CITY OF ALBUQUERQUE PARKS AND RECREATION DESIGN AND DEVELOPMENT					
Valley Pool Planting Plan					
APPROVAL		ENGINEER	DATE	APPROVAL	ENGINEER
City Eng.				Liquid Waste	
A.C.E.-B				Traffic	
A.C.E.-I				Water	
DRA. NO.		MAP NO.		SHEET OF

CITY OF ALBUQUERQUE PARKS AND RECREATION DESIGN AND DEVELOPMENT					
TITLE: Valley Pool Details Section					
APPROVALS	ENGINEER	DATE	PROVALS	ENGINEER	DATE
City Engineer					
A.C.E. Design					
A.C.E. Hydro					
DRAWING NO.	1 OF 1

VALLEY HIGH SCHOOL POOL
RENOVATION

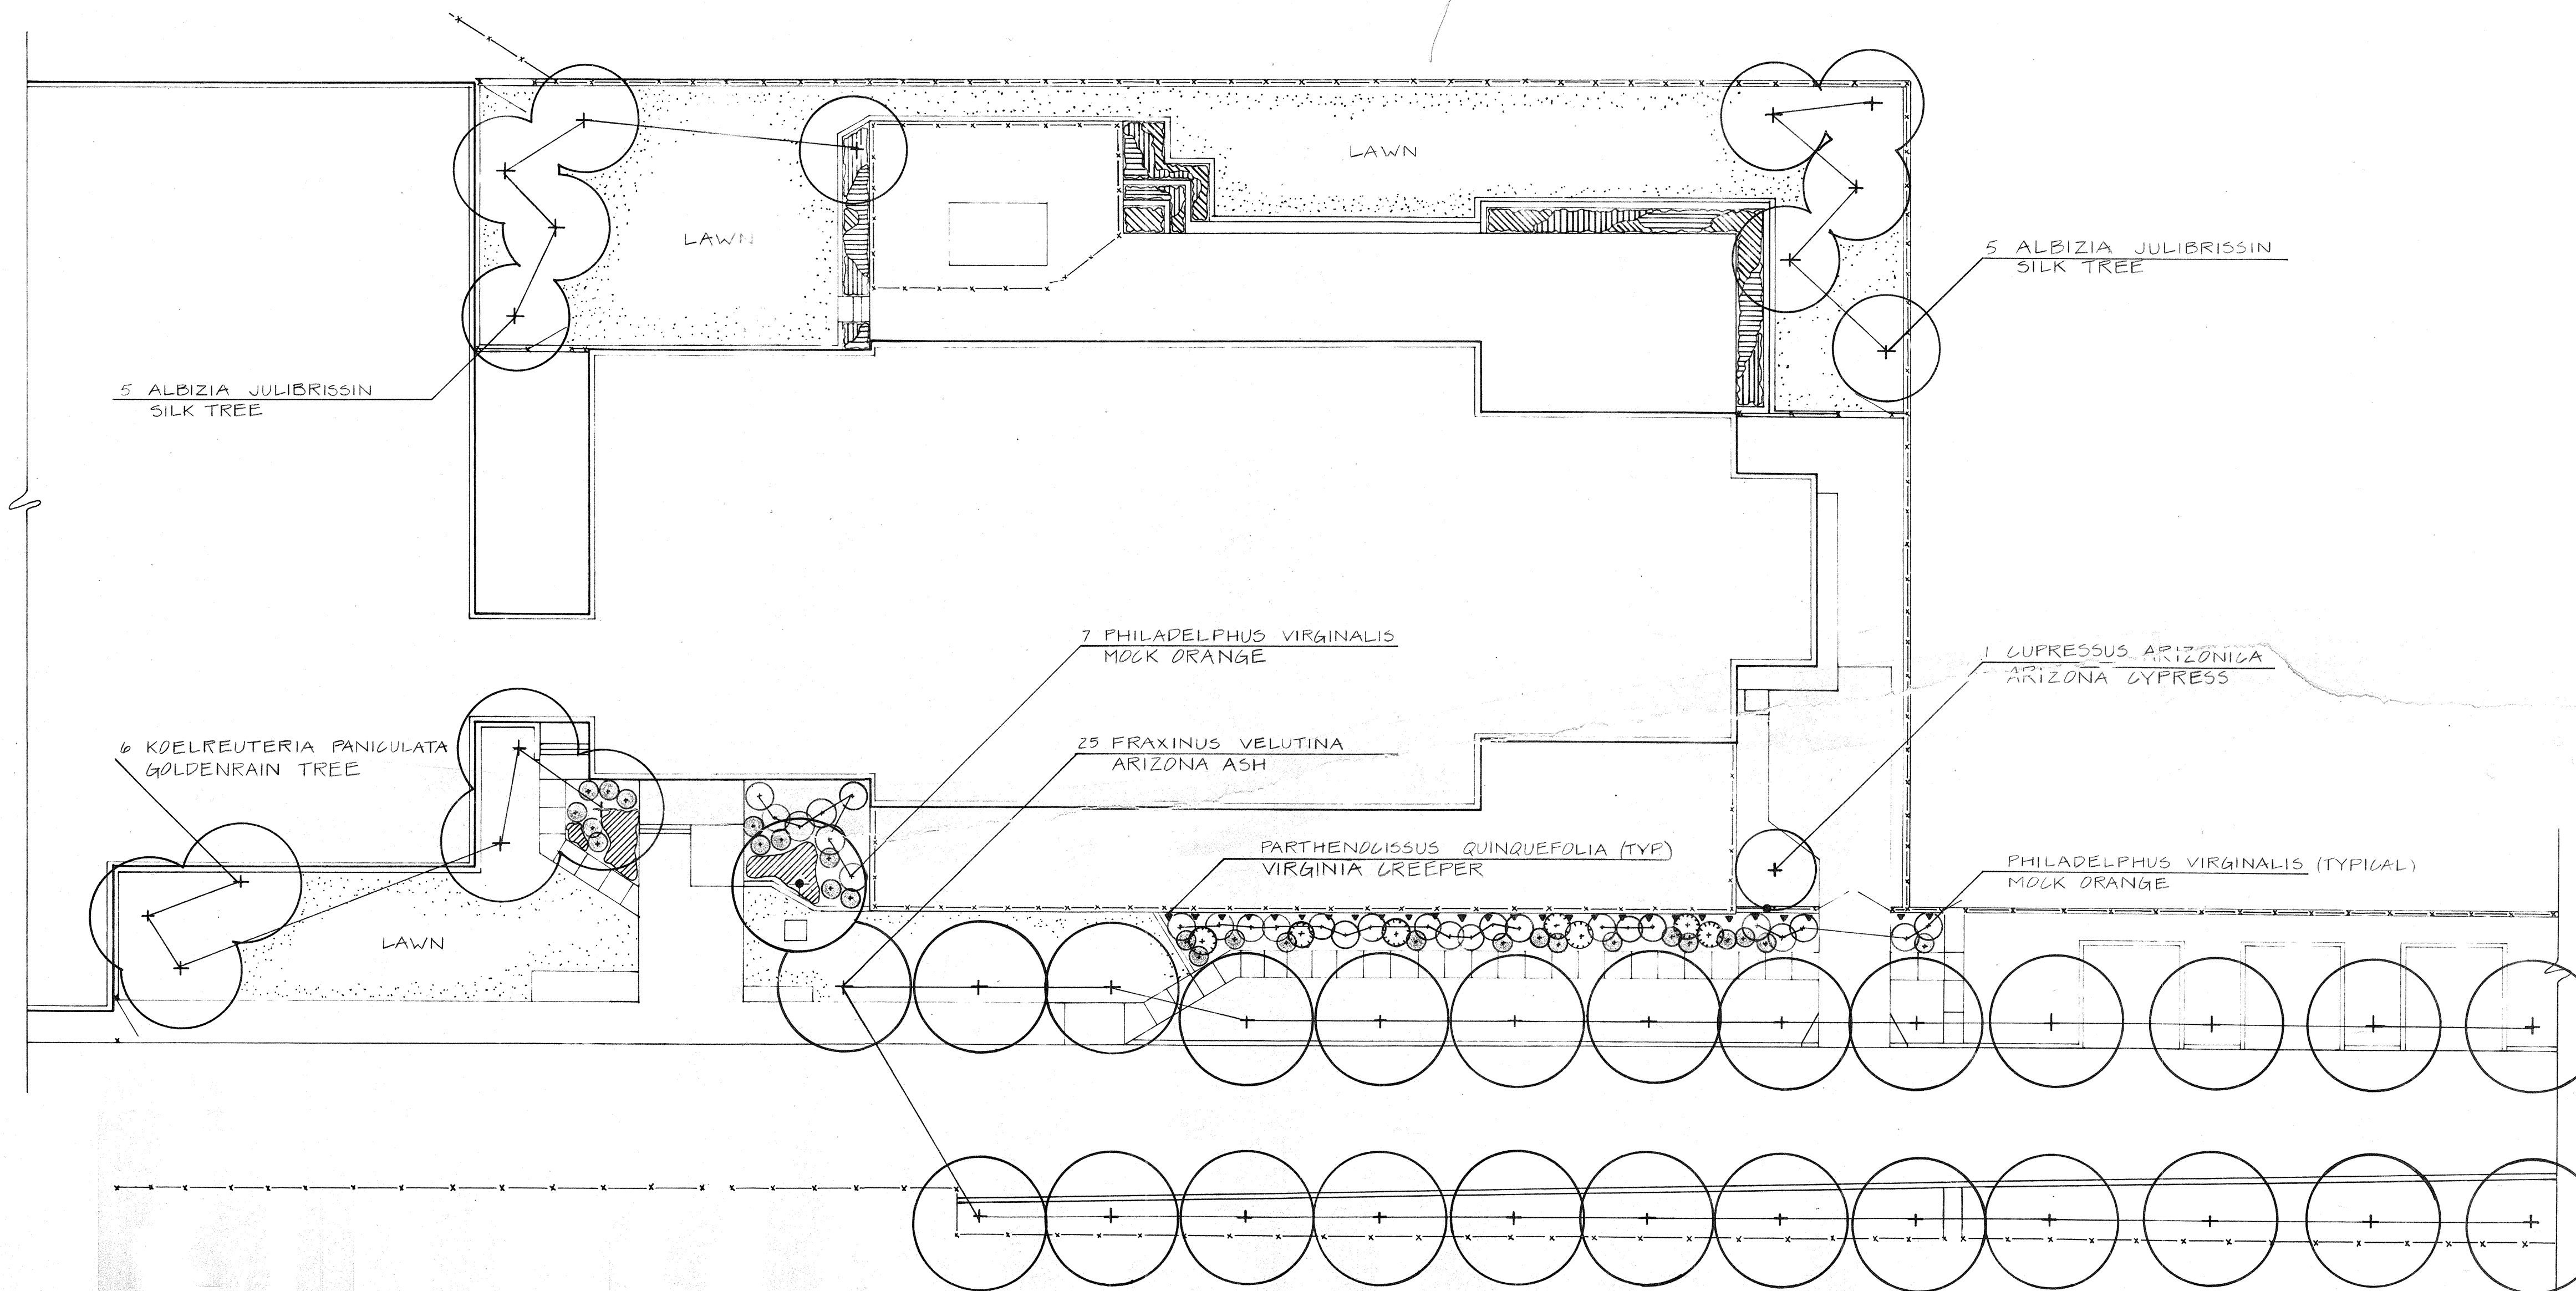
6' ? can we get 8' ?

Chainlink Fence
N.T. TO SCALE

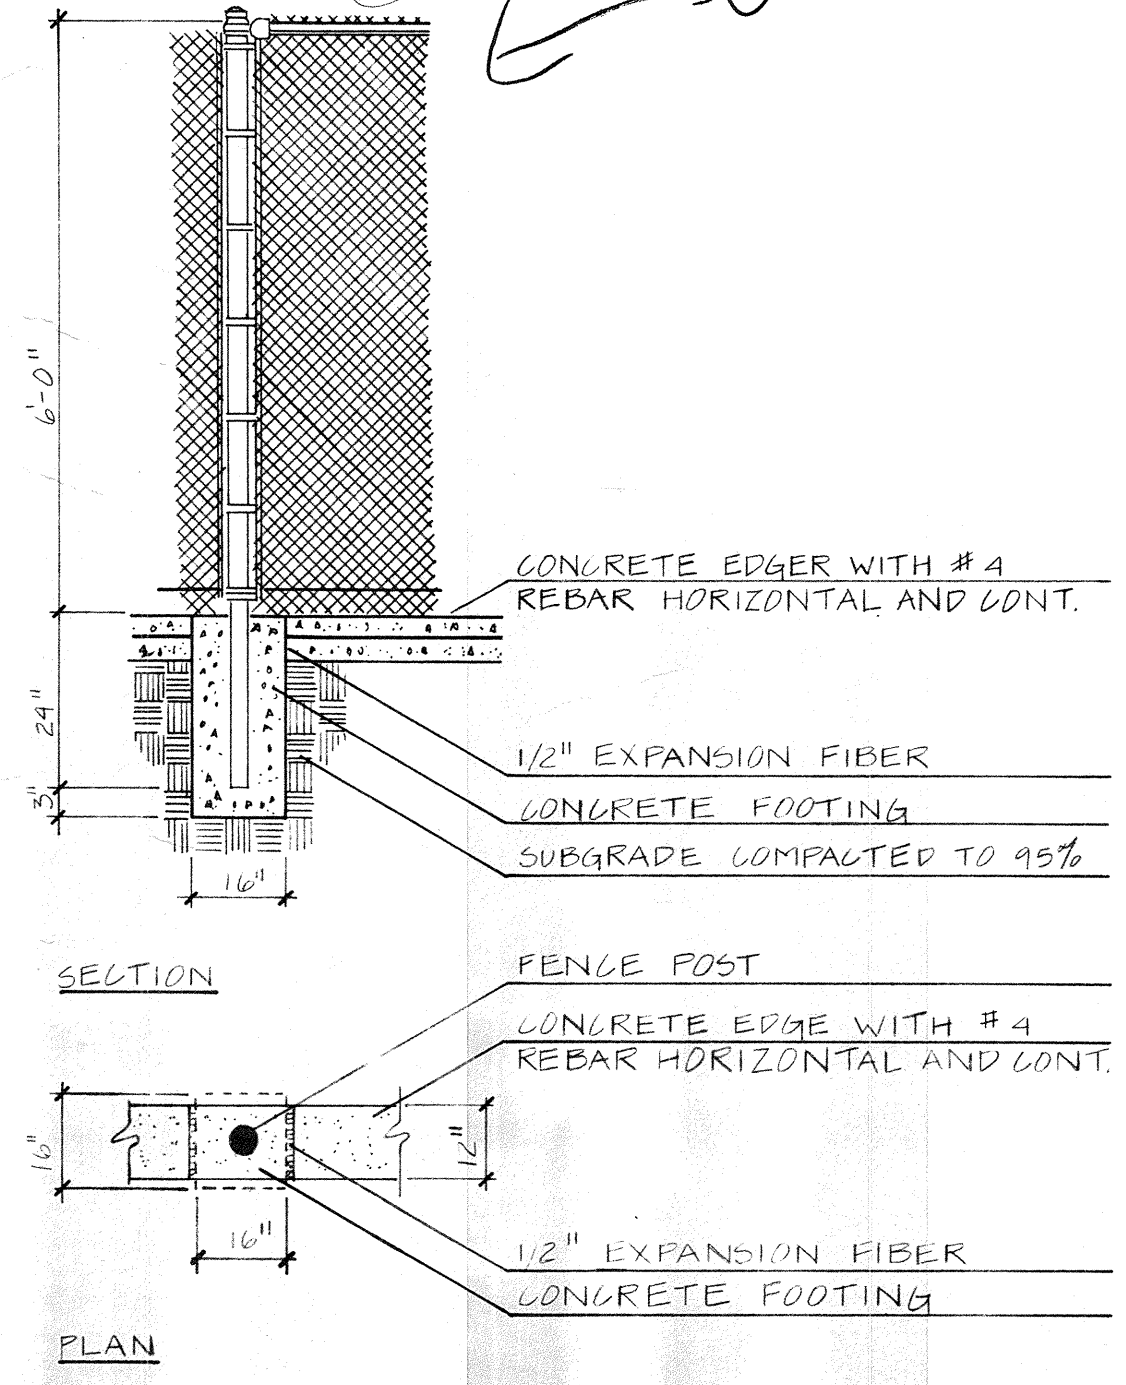
*no banded with →
could finish be higher?*
